Form C-103

Elk Wallow 11 State

SUNDRY NOTICES AND REPORTS ON WELLS
(DO NOT USE THIS FORM FOR PROPOSALS TO DRILL OR TO DEEPEN OR PLUG BACK TO A
DIFFERENT RESERVOIR. USE "APPLICATION FOR PERMIT" (FORM C-101) FOR SUCH
PROPOSALS.)

Elk Wallow 11 State 005 Current and Proposed WBD's

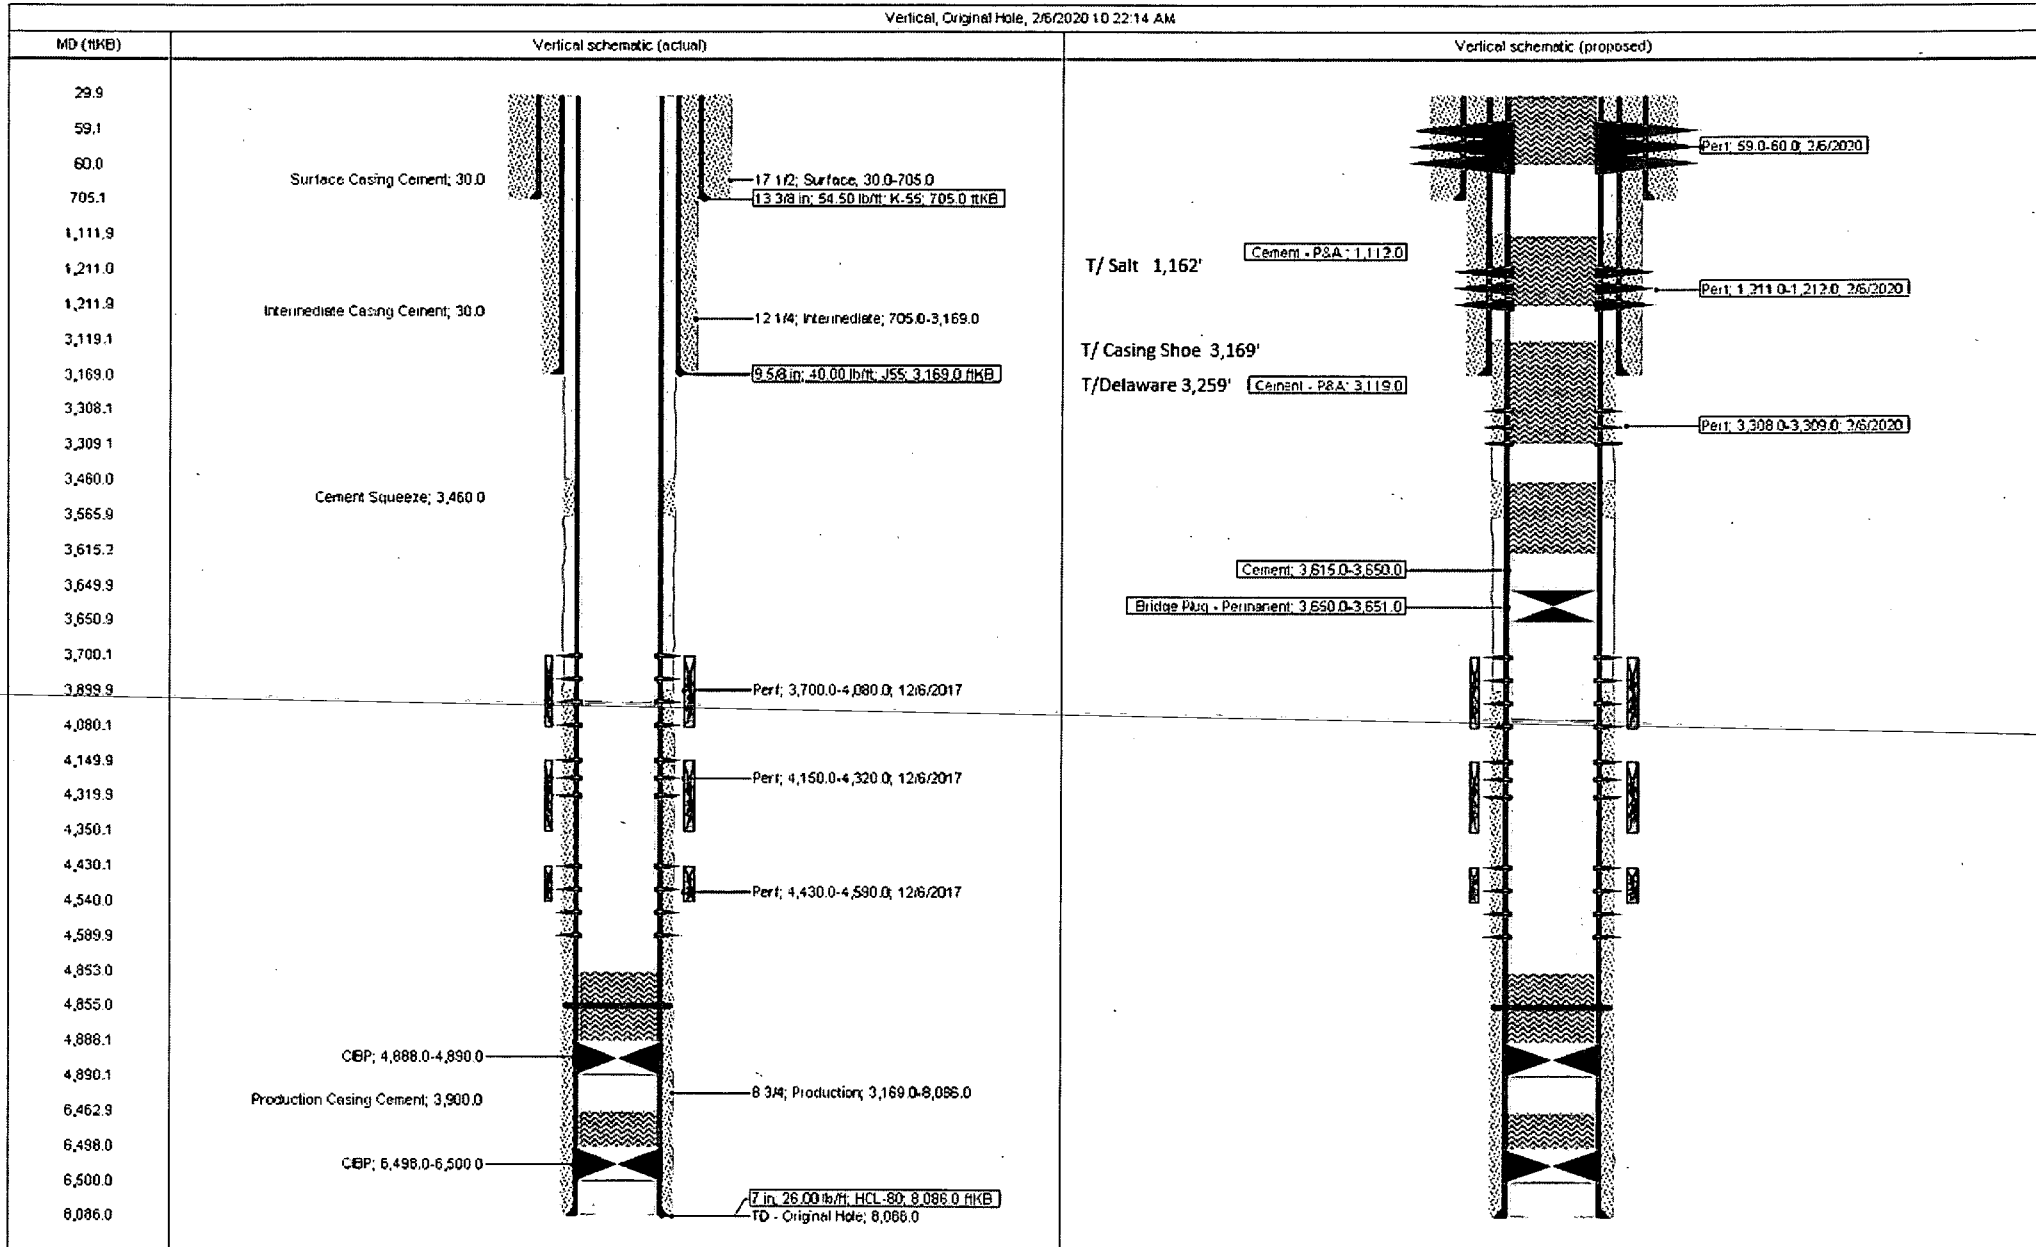
Perf @ 3220 + A Hempt to Sqz.
4. Perf 7" csg at 3,309'. RIH w/tbg and sqz 115 sxs Class C cmt. WOC & Tag at least 3,119'. (T/Delaware and Casing Shoe)

Perf @ 755' + A Hempt to Sqz.
6. Perf 7" csg at 60'. RIH w/tbg and sqz 35 sxs Class C cmt to ensure plug top reaches surface. WOC & Verify at surface. (Surface Plug)

*** SEE ATTACHED COA'S - Revised
MUST BE PLUGGED BY
2/24/21
